ADDENDUM # 1
Date of Addendum: March 21, 2014

NOTICE TO ALL BIDDERS AND PLANHOLDERS

ALCOVE SALVAGE PLAN

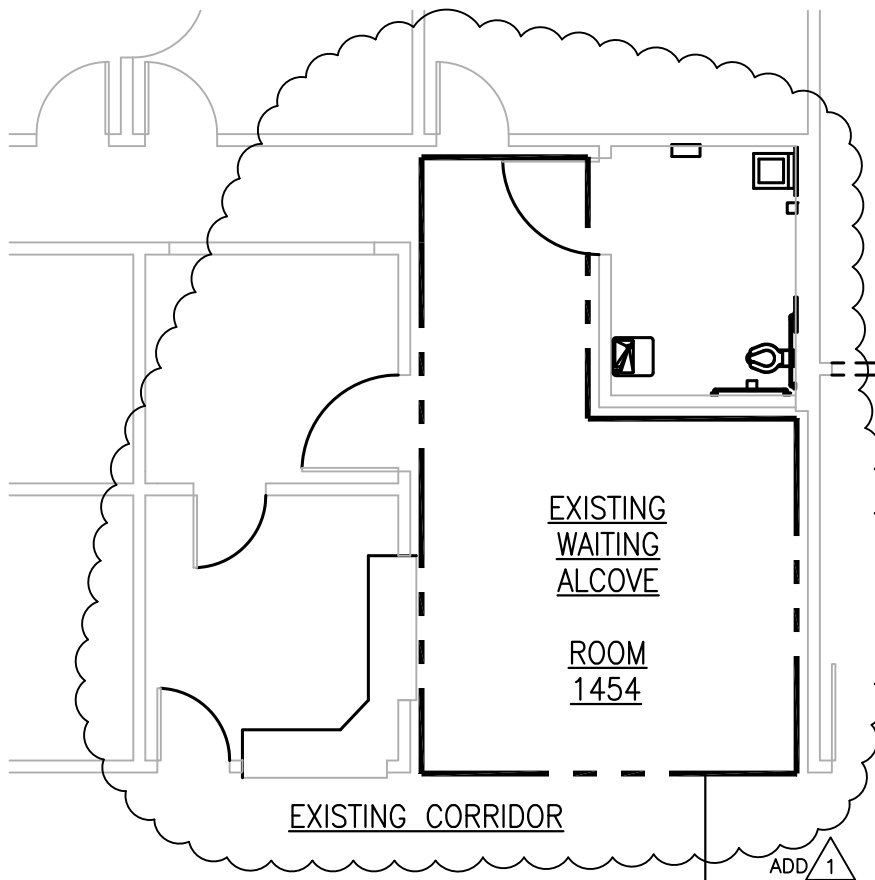
Item	Drawing No.	Clarification Dwg. No.	Description of Change
2.1			REFER TO RFI RESPONSES UNDER SEPARATE COVER.
2.2	AE-101	CD A-1	Demolition/salvage requirements for Room 1454
2.3	AE-101	CD B-1	Locations/types of vinyl tile in Room 1456

CAREFULLY REMOVE AND SALVAGE ALL EXISTING ACRYLIC WALL PANELS, LIGHT FIXTURES, CEILING TILES, CHAIR RAIL AND TERRAZZO FLOOR TILE, AND SET ASIDE IN PROTECTED AREA AS DIRECTED BY THE V.A. PROJECT MANAGER.
